Detroit
Edison

Subject: Semi-Annual Radiological Effluent Release Report

DETROIT EDISON COMPANY
FERMI 2 NUCLEAR POWER PLANT
OPERATING LICENSE NO. NPF. - 43

SEMIANNUAL RADIOACTIVE EFFLUENT RELEASE REPORT

FIGURE 2.0-1
Liquid Radioactive Effluent Monitoring and Processing Diagram

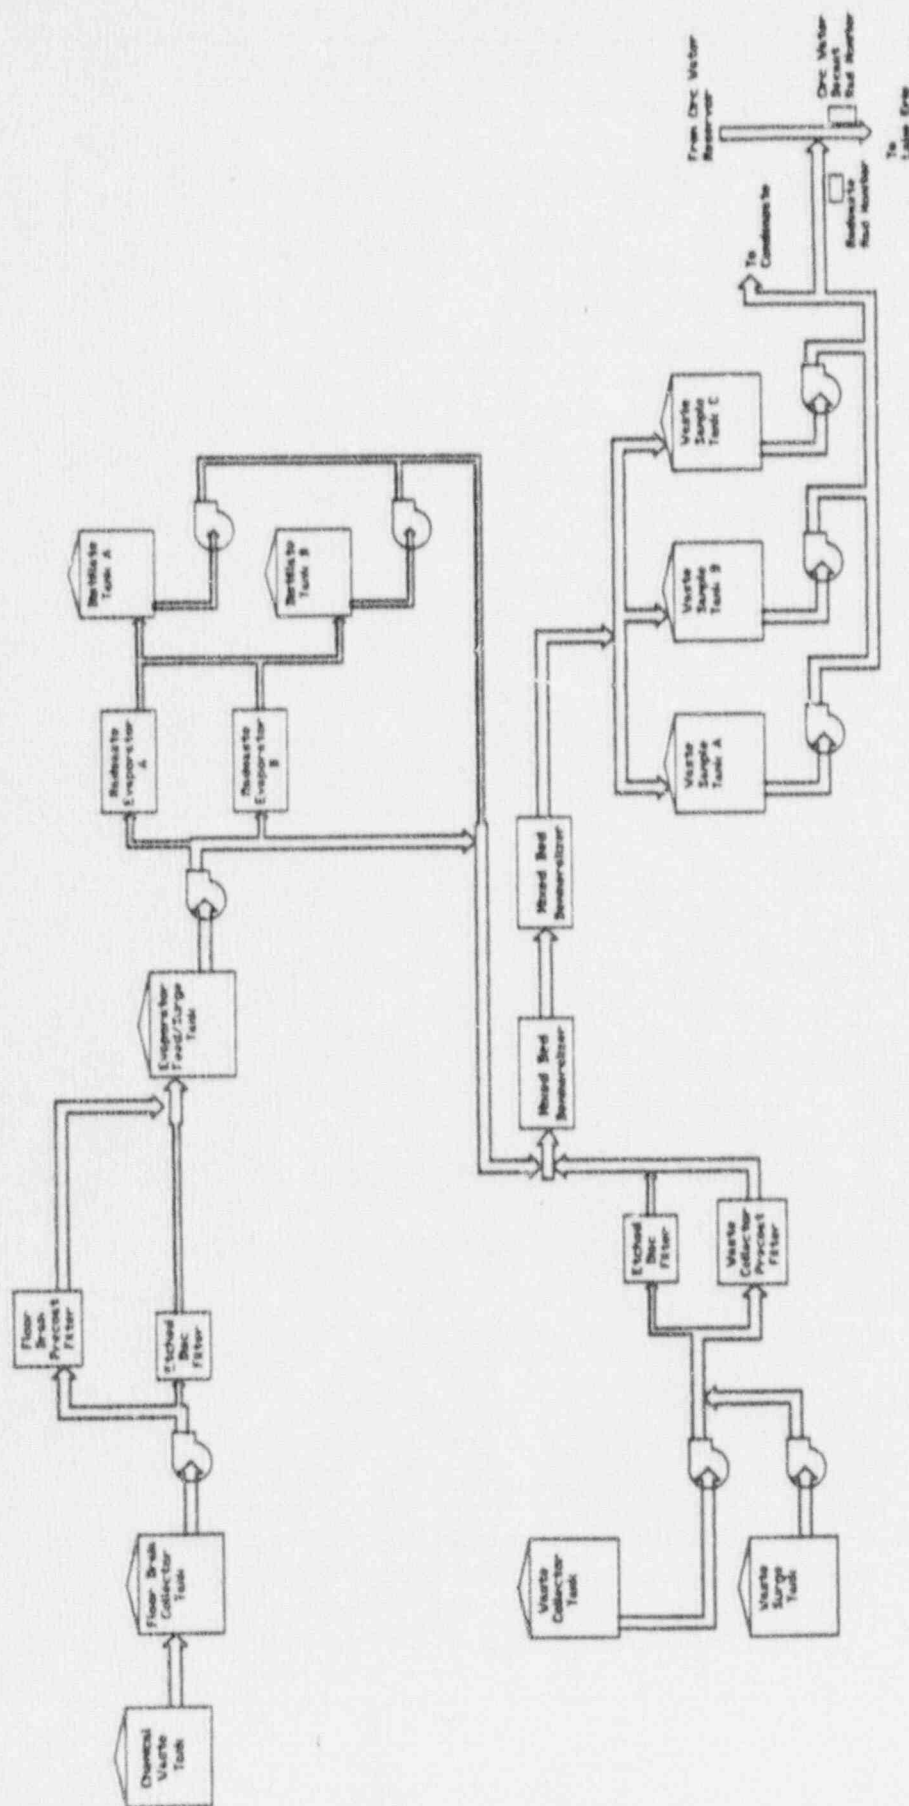
B) Section(s), Table(s), Figure(s), etc. Affected
0.0, 1.0, 2.3.1, 2.3.2, 2.3.3, 2.6, Fig. 2.0-1, 3.2.2, 3.3, 3.5, 3.6.1, 3.8.1, 3.9,

C) Reason for Change Tables 3.0-2, 4, +5, Tables 4.0-1 and 6.0-1, Figures 6.0-1 through 6.0-5, 8.0, Appendix A
Correct tables with updated values, improve readability, revise calculation methods, etc.

FIGURE 1
SAMPLING LOCATIONS
BY STATION NUMBER
(SITE AREA)

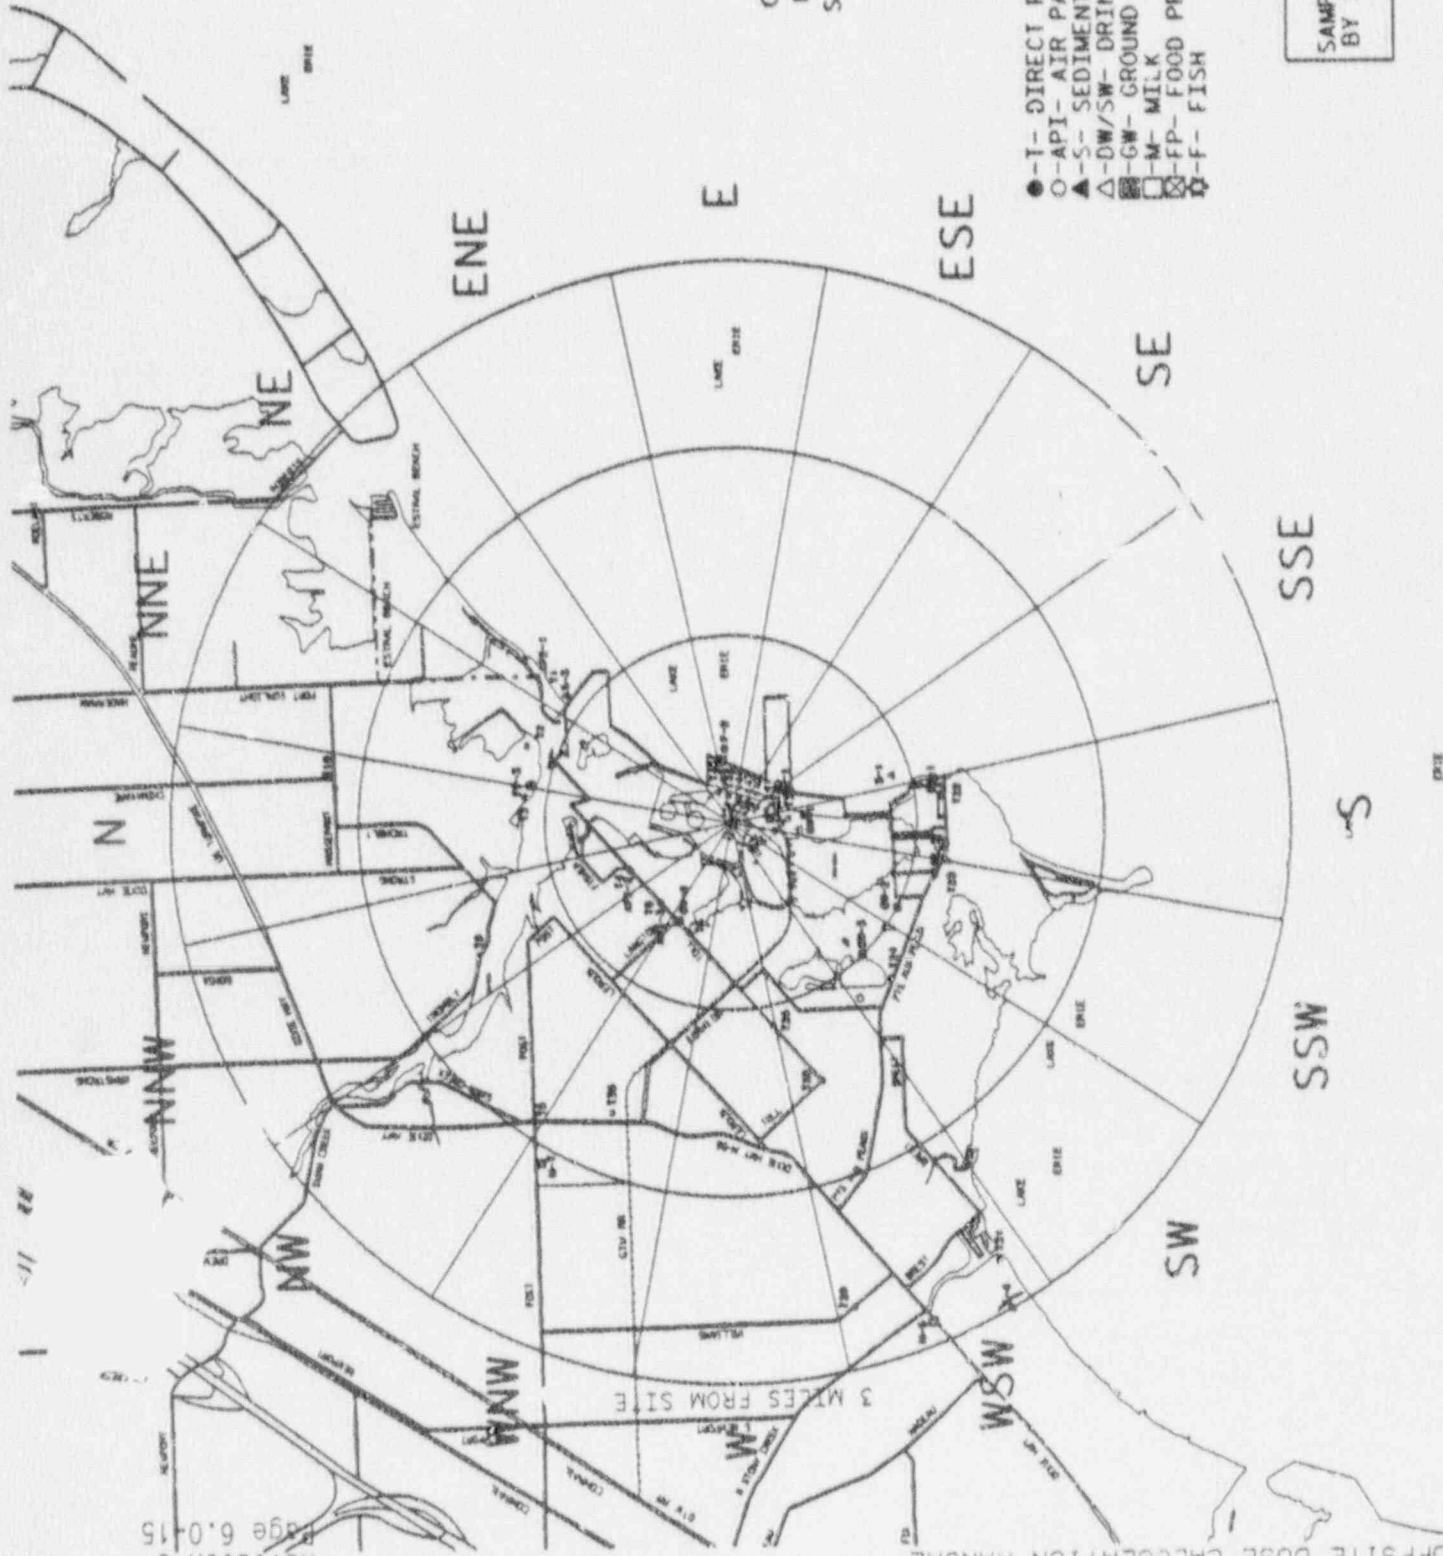
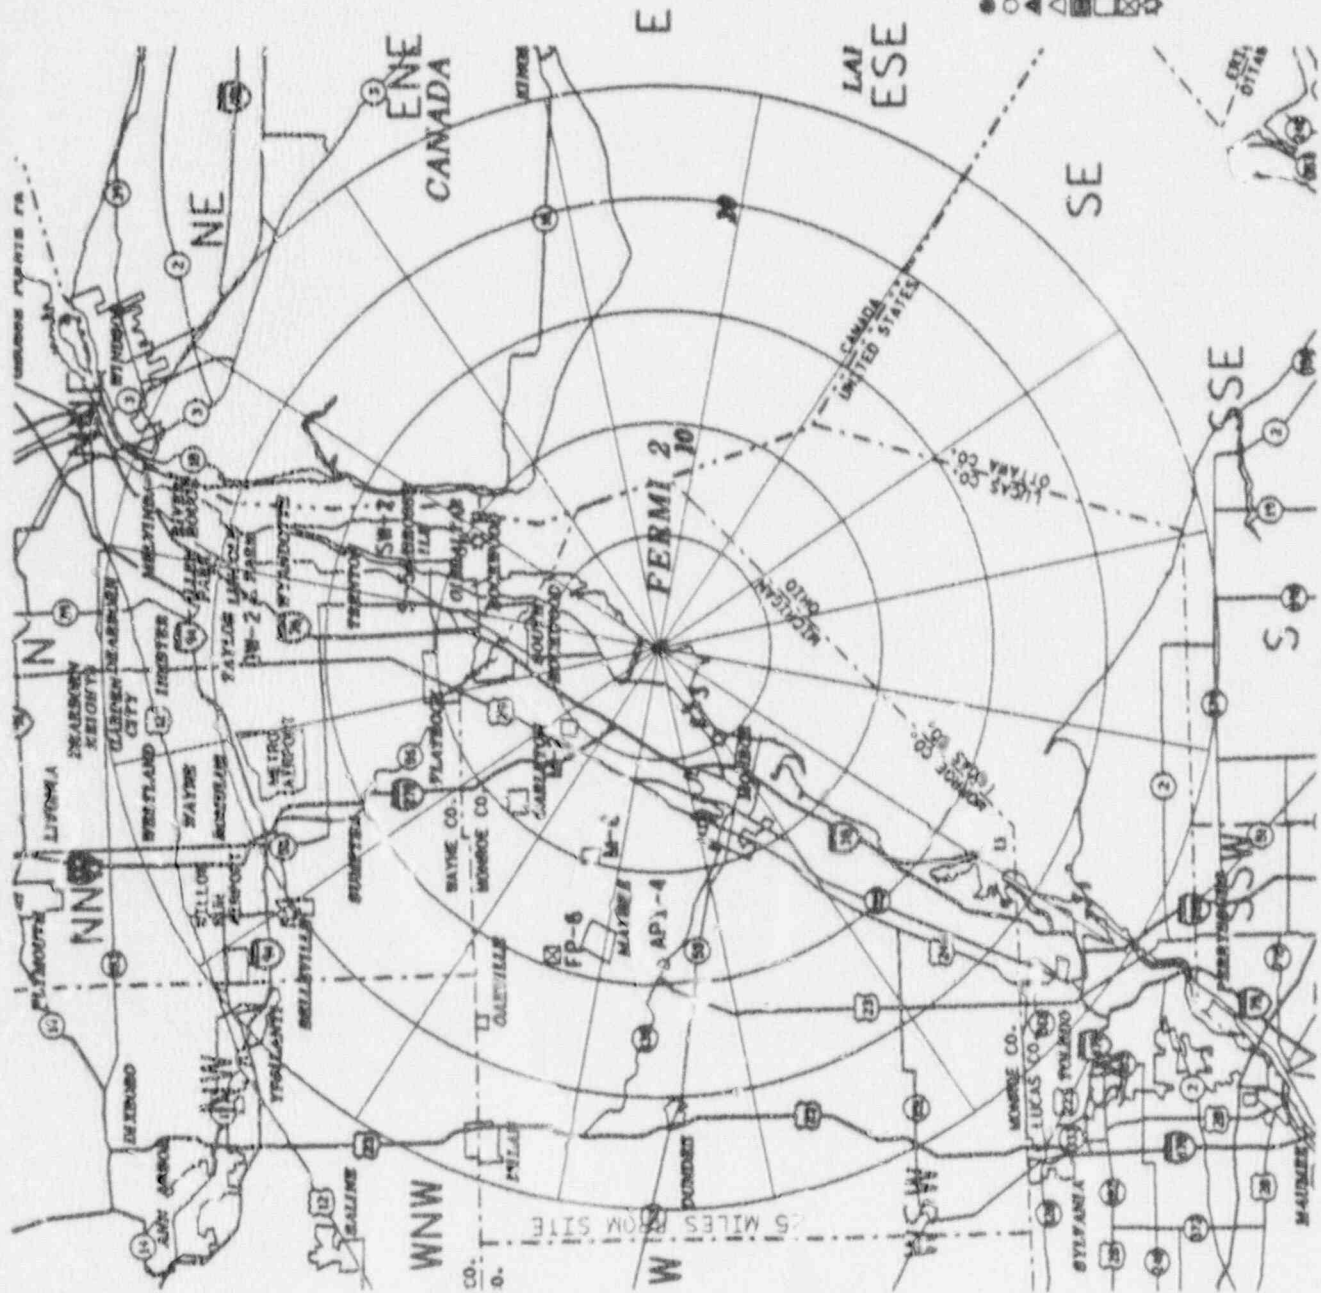
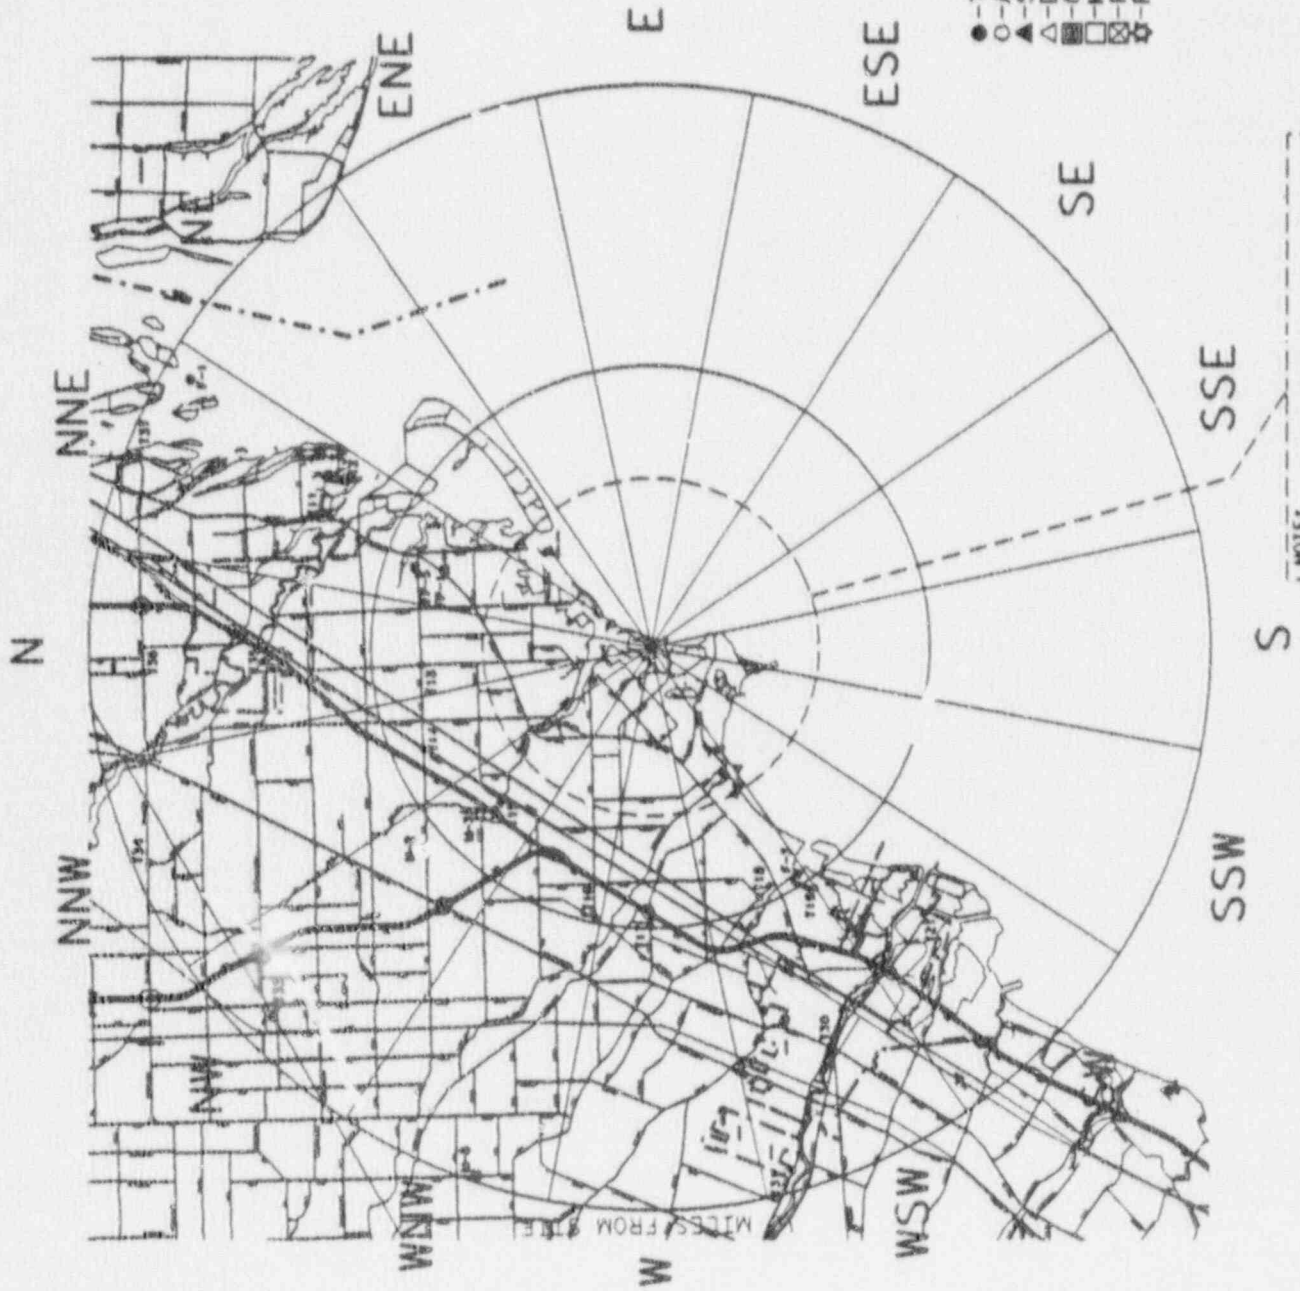
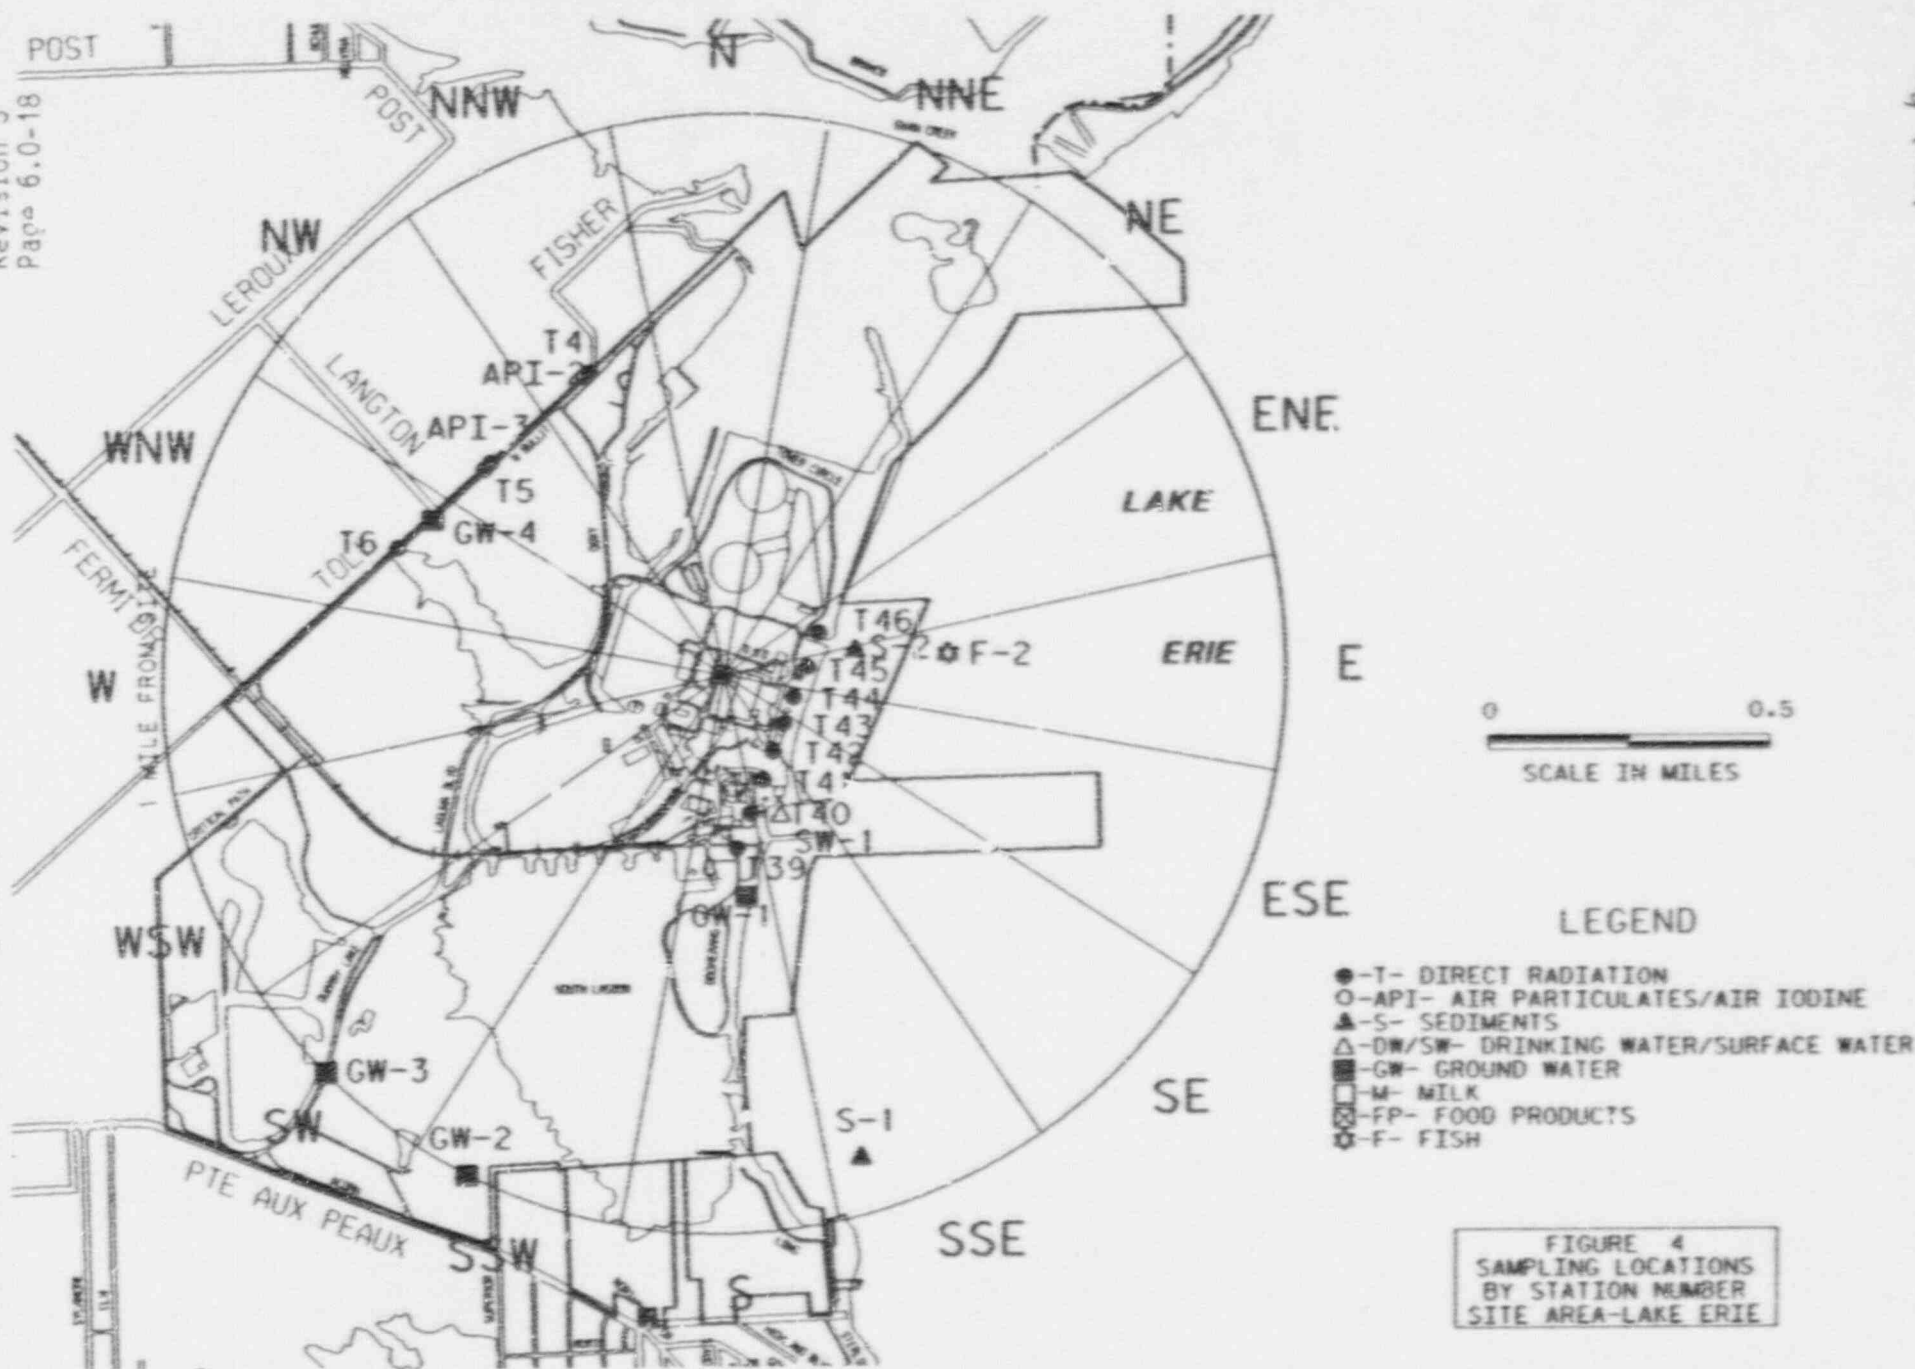
Section/Page	Change	Basis
		census activity.
		Additionally, per the
		bases of T.S. 3/4.12.2,
		the land use census is
		for areas at and beyond
		site boundary, so it is
		not meant to cover areas
		within the boundary
		anyway.
6.0-8,11,12	Update and correct REMP	Sampling locations
	tables based on current	change because of land
	sampling locations and	use census data partici-
	new distance calculations	pation by the public in
	and latest land use census	the REMP, critical
		receptor analysis, and
		distance recalculation
		by DECo cartographers.
6.0-15 through 19	Improve readability of	N/A.
	maps.
